## SERVICE BULLETIN 12-11-09 ADDENDUM

Issue Date: 13-01-08

This Addendum supplements and clarifies the contents of Service Bulletin SB 12-11-09

**FIGURE 14A:** CR32XX MANUFACTURED HEAD EXAMPLE

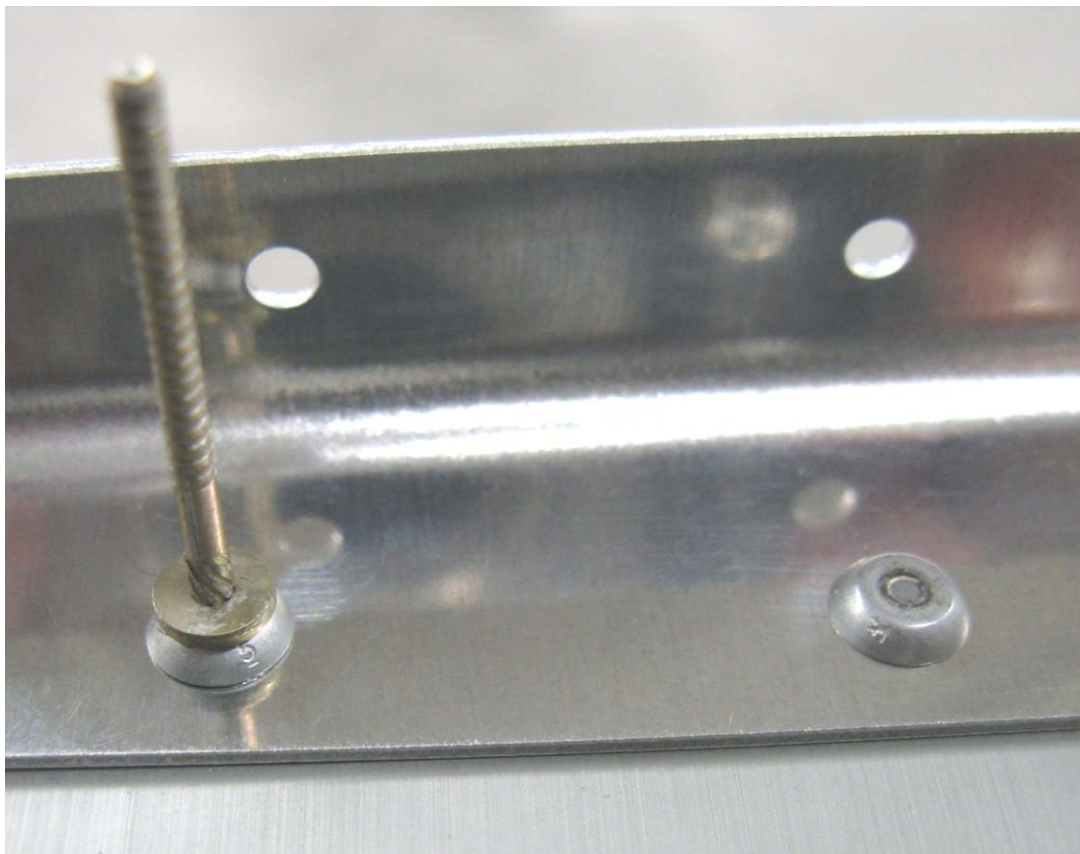
[Step 2]: Verify correct rivet part number which is marked on the head of the rivet as shown in left-hand side of Figure 14A.

[Step 3]: Insert rivet in hole and verify manufactured head fits square and flush to material surface. See the left-hand side of Figure 14A.

[Step 5]: Operate tool while taking care to not lean tool or bend rivet stem while doing so. Continue to pull rivet stem until it snaps free as shown in right-hand side of Figure 14A.

- i. Nearly flush surface due to stem fracture at top of manufactured head. See right-hand side of Figure 14A.

- ii. Base of manufactured head should be tight against surface of material being riveted as shown in right-hand side of Figure 14A.

**FIGURE 14B:** RIVET CROSS SECTION

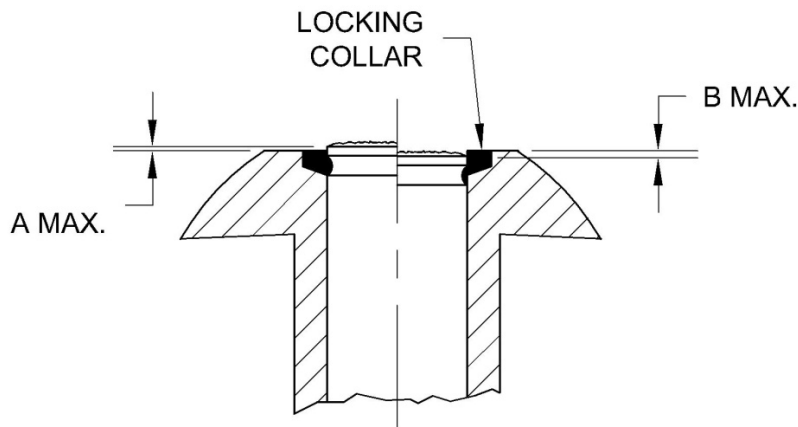
Typical fastener flushness acceptance criteria is shown in Figure 14B and listed in Table 2 below. Locking collar is to be flush with top surface of rivet head. Collar flash permissible is .020 max. Stem flushness shall be as indicated.

**FIGURE 14C:** CR32XX SHOP HEAD EXAMPLE

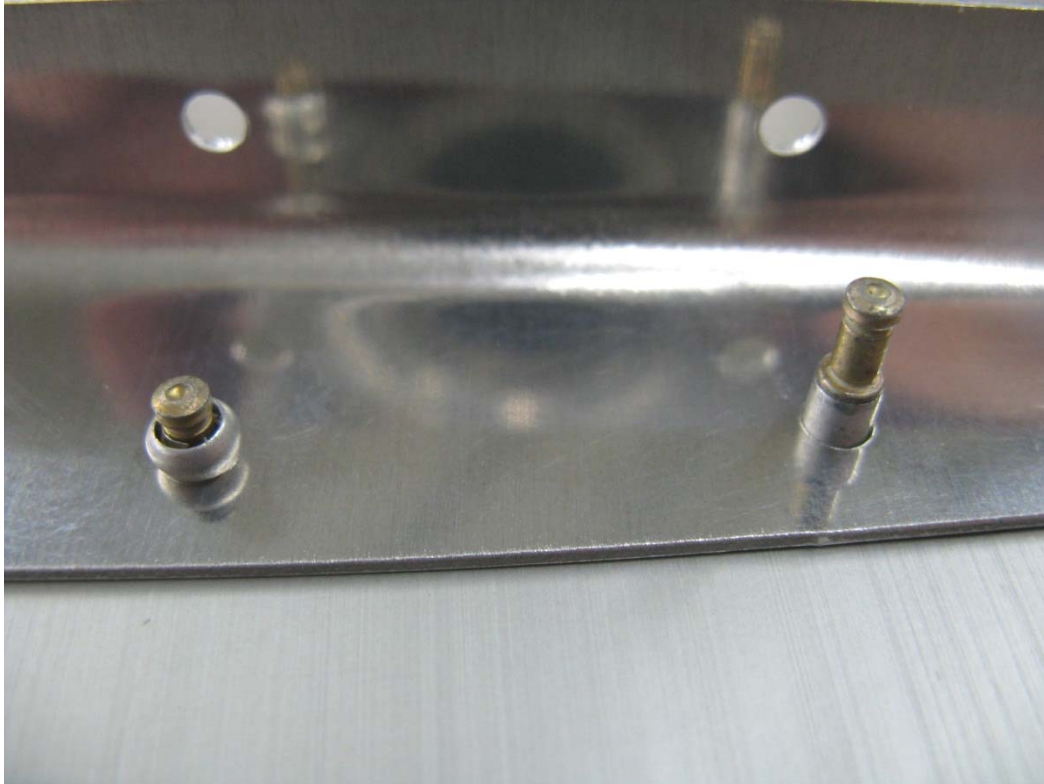
- iii. Stem will not be pulled fully into rivet body at shop head end, but rivet body should have formed (closed up) around stem as shown in left-hand side of Figure 14C. See Figure 14D for acceptable blind head formations.

**FIGURE 14E:** ATTACHING SKIN STIFFENER ANGLES TO CENTER SECTION CHANNEL USING CHERRYMAX CR32XX RIVETS  
(NOTE: RIVETS ARE SHOWN INSTALLED FROM THE UPPER SIDE)

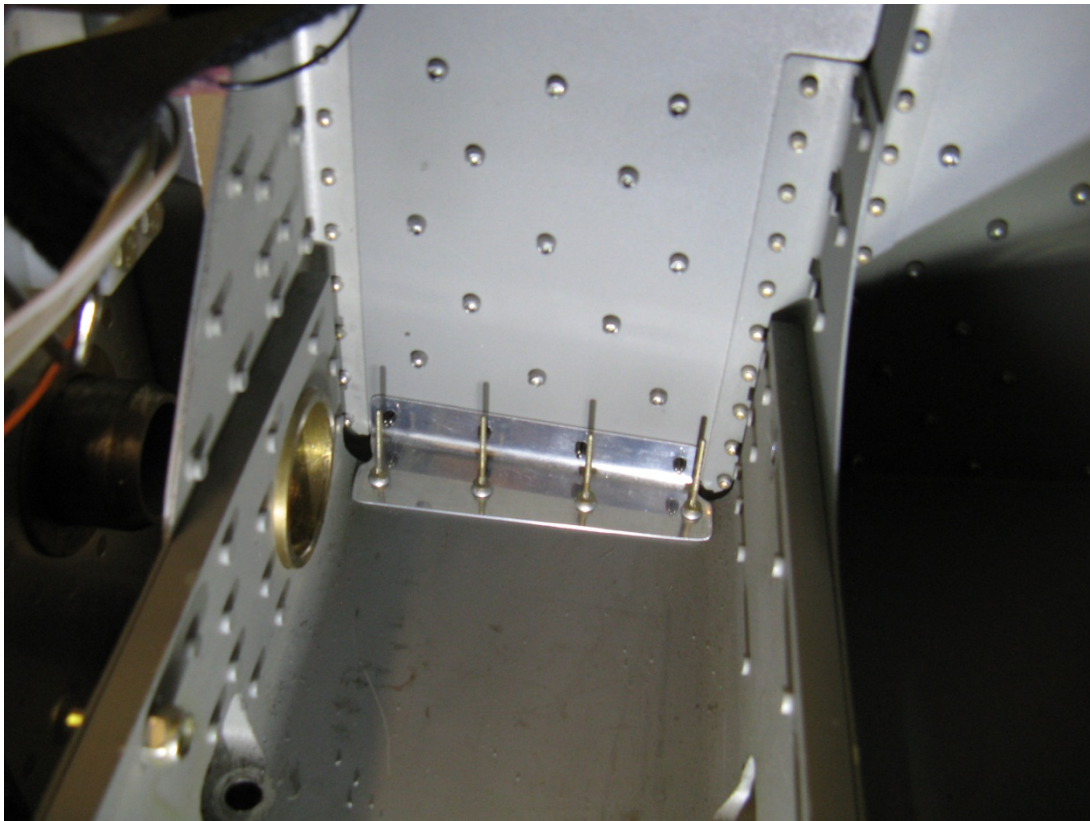
Step 30: Tap the Spar Pin Bushing in the left and right sides of the F-1204 Center Section fwd slightly to provide access to the fwd most rivet that attaches the F-1204U-B L & R and F-1204T-2 L & R Angles.

**NOTE: In Figure 14E rivets are shown installed from the upper side. IT IS NOT PERMISSIBLE FOR THE STEM OF THE RIVET TO BE BENT OVER DURING INSTALLATION. If the side skin in combination with the size of the rivet puller does not permit pulling squarely without bending the rivet stem then you must either locate a different puller or the rivets must be installed from the bottom side. See "COVER PLATE REMOVAL" below.**

Rivet the F-1204U-B L & R and F-1204T-2 L & R to the F-1204 Center Section Assembly using CR3213-4-5 rivets as shown in Figure 14E.

**FIGURE 14F: F-1275G-L COVER PLATE REMOVAL**

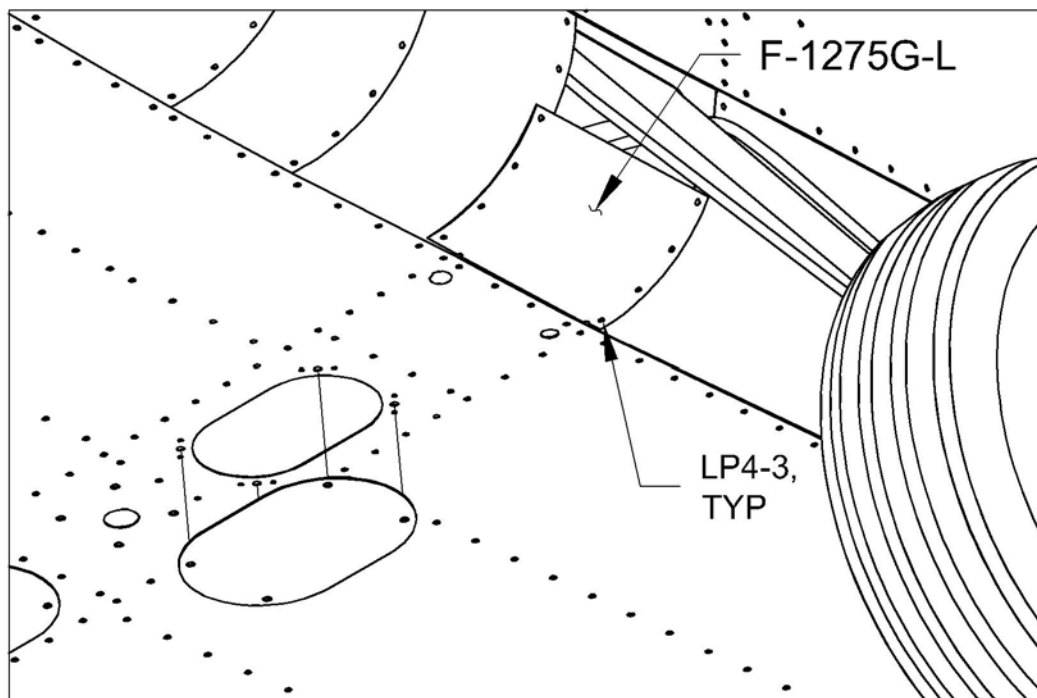
This procedure is only necessary if it's not possible to install the CR32XX rivets from the upper surface of the Center Section, as shown in Figure 14E, and for reasons mentioned in the NOTE above.

[Step 1]: Drill out the existing LP4-3 rivets attaching the Cover Plate to the surrounding skins and remove the F-1275G-L and F-1275G-R (not shown) Cover Plates.

[Step 2]: Insert rivets called out in Step 30 through the underside of the Center Section Assembly and F-1204U-B-L Skin Stiffener and rivet them together. Repeat for F-1204U-B-R Skin Stiffener.

[Step 3]: Cleco then rivet the F-1275G-L and F-1275G-R Cover Plates back into place using the rivets called out in Figure 14F.
